Cooper Creek Cedar Ltd.

RE: Site Review of CP 404-6 and CP 404-15, Laird Creek Area.

Will Halleran, P.Geo., Apex Geoscience Consultants Ltd.

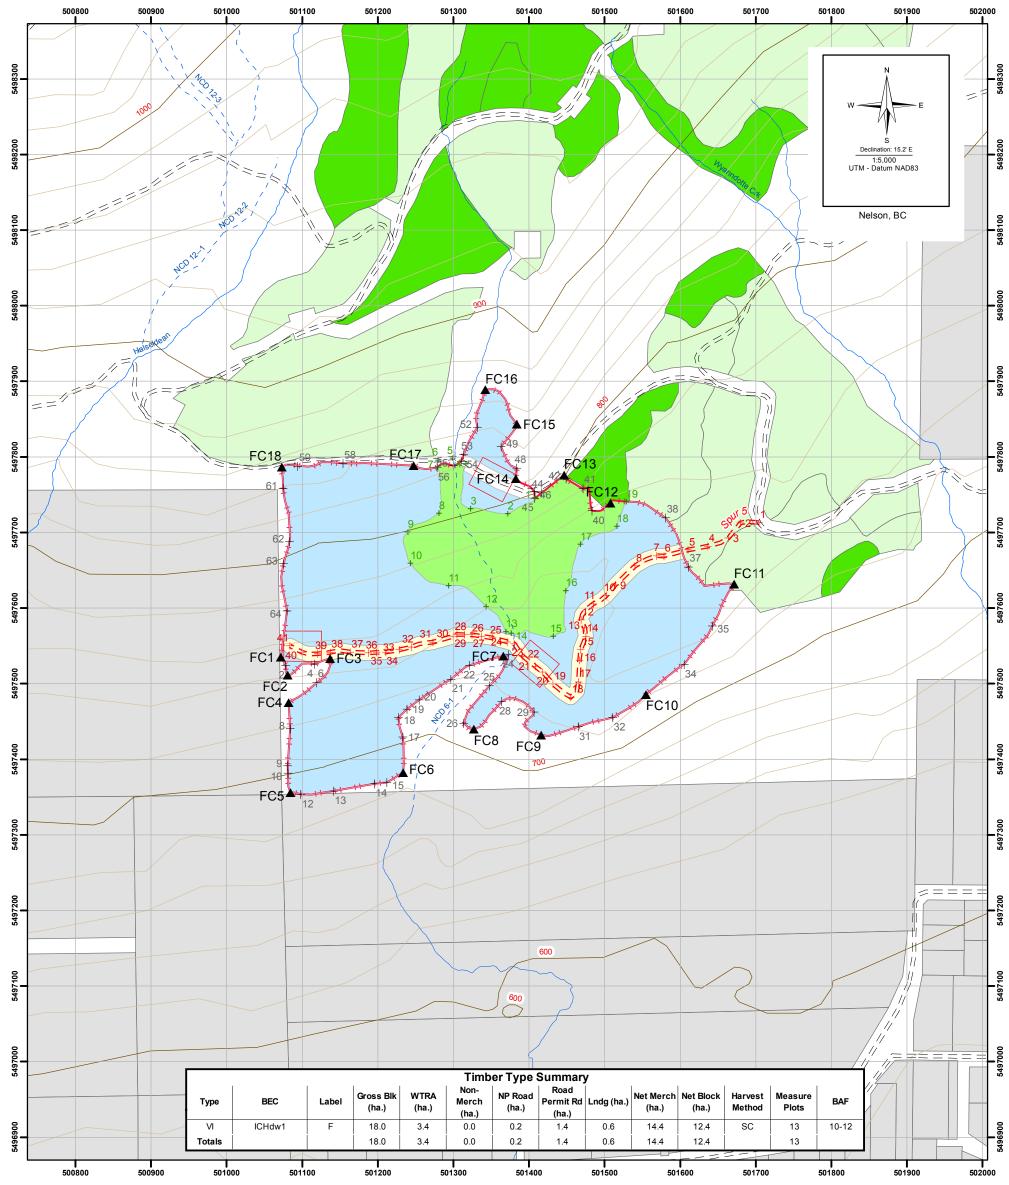
404-15: During the field review we walked the proposed road, traversed down adjacent to NCD 41-1, then followed the falling boundary. Ground skidding clear cut is prescribed adjacent to the proposed road, Clear cut cable yarding is proposed for the remainder of the block. The upper lift of the proposed road follows and old existing haul road. There are a series of small streams that flow through the block confined in small draws which open up downstream, there is evidence of high flows within the last 25 years. For the most part the slope has a moderate slope gradient. There is no evidence of instability associated with the streams, there is an area of wash of material off shallow rock near a

seasonal spring likely about 25 or more years old. There is a large spring in the lower portion of the block, likely where subsurface water is forced to the surface by shelving rock. A trench just upslope of the spring appears to have been constructed to intercept, concentrate, and divert subsurface and surface flows for consumptive purposes. This trench should be flagged, cable yarding across the trench should be conducted in such a way to ensure the trench is not breached (gouged) or filled. If this recommendation is implemented, timber harvesting as proposed is unlikely to have a noticeable effect on the slope hydrology, there are no terrain stability concerns associated with the proposed development.

Document Path: G:\PROJ\cooper_crk\CP404_Laird\maps\Cruise Plan Maps\CP404_Blk6.mxd

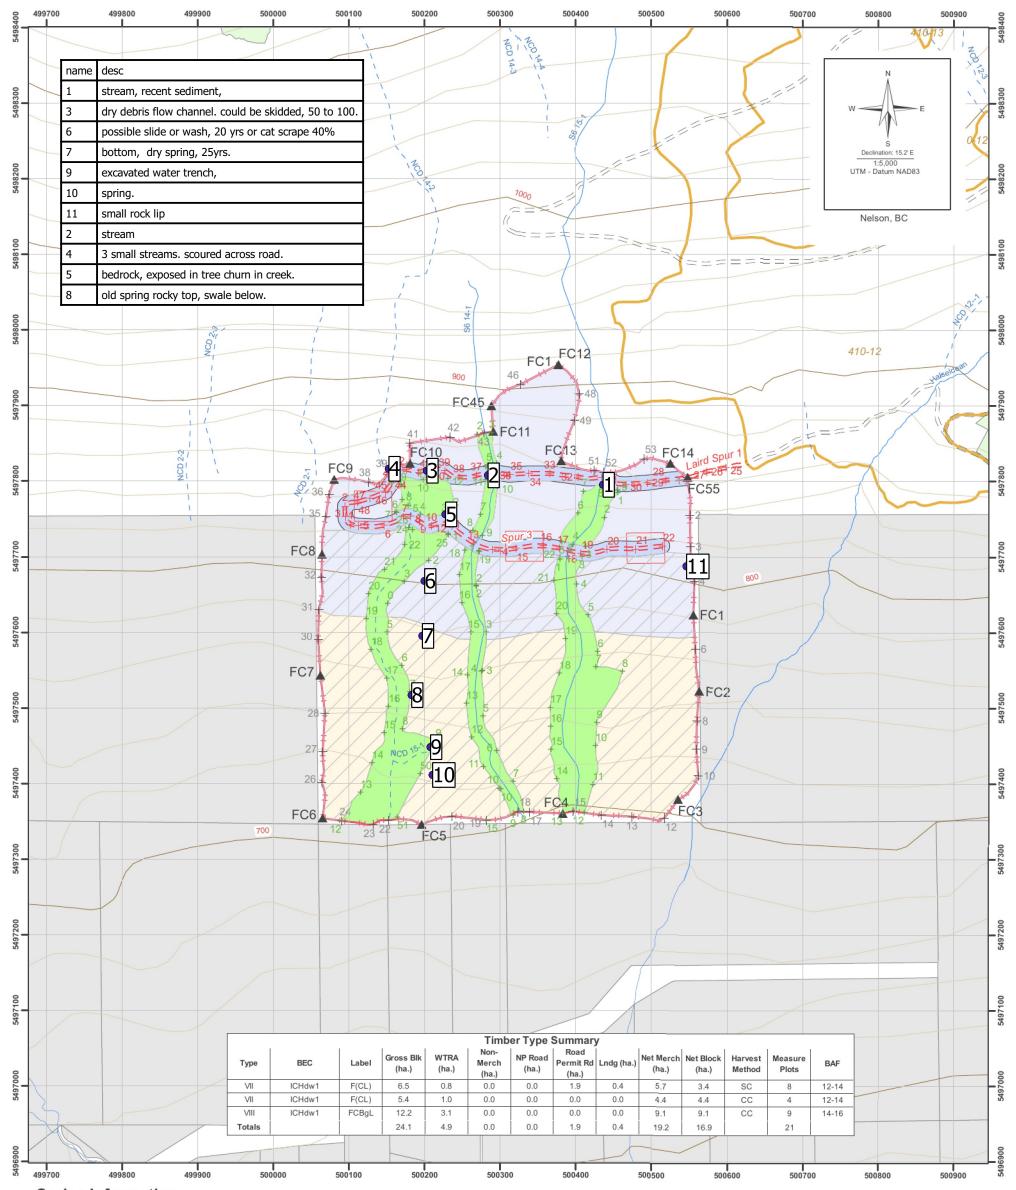
404-6: During the field review we walked the proposed spur and portions of the lower boundary. The harvesting plans call for clearcut with ground skidding. Proposed Spur 5 traverses though the middle of the block, the existing road forms the upper boundary. There are old roads and trails (used for firewood harvesting) within the block. There is no evidence of instability, well defined draws and ridges control the slope drainage. One NCD is mapped flowing down through the middle of the block (most of the NCD is within a reserve). Most of the catchment for the NCD is upslope of the proposed block. Timber harvesting is unlikely to influence the water quantity, quality, or timing of flows.
